DRAINAGE LETTER
for
FALCON SHERIFF SUBSTATION

Tract B of Tract 36 Woodmen Hills Filing No. 11
12062 Royal County Down Road
Falcon, Colorado

November 13, 2022

PCD File No: PPR2259

Design Procedure Form:

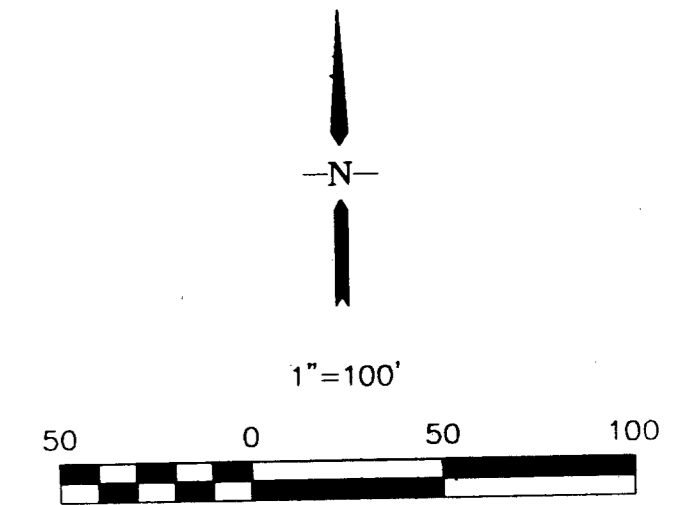
Should this be 4.4 acres, or 192,000SF?

finish the design spreadsheet with proposed basin geometry and existing outlet structure orifice diameter. Include forebay design spreadsheet

PROPOSED DRAINAGE PLAN

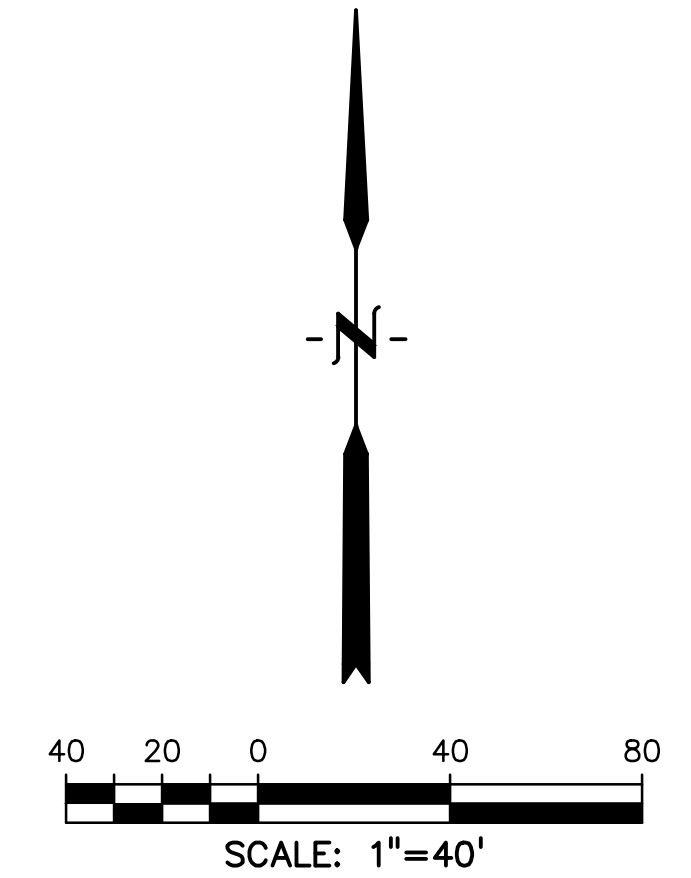
Highly recommend that this is storm pipe be changed to 18" RCP which is the min. County allows for public storm sewer system.

Please clarify whether any flows from the roadway will enter the site.
